MEMORANDUM

RE: 99 Main Street

Michael Lewis Architects P.C. (the “Applicant” and “Contract Vendee”) is seeking Site Plan approval from the Village Board of Trustees for improvements to the existing basement and first floor in addition to the construction of three (3) additional floors of apartments above the existing footprint. The property is located at 99 Main Street, Section Block and Lot 3.80-40-9 (“Project Site”) and is in the DB, Downtown Business, zoning district. The Project will require referral to Westchester County Planning Board as it is within 500 feet the Old Croton Aqueduct State Trailway and is proposing over 5,000 sf of new or renovated floor area.

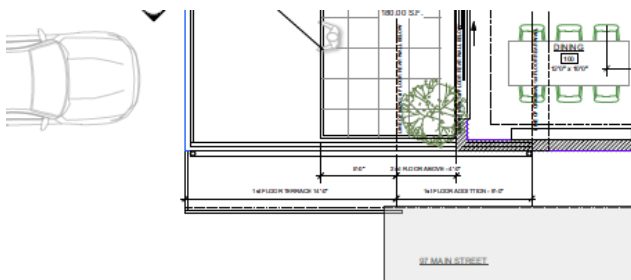
4. **Skylight.** The location of the skylights identified on the fourth floor and the roof do not seem to align. Please clarify.
5. **Fence and gate.** It appears the proposed fence and gate at the rear of the alley may be located on the adjoining property at 97 Main Street. Please clarify the location of the fence/gate in reference to the property line. See below.
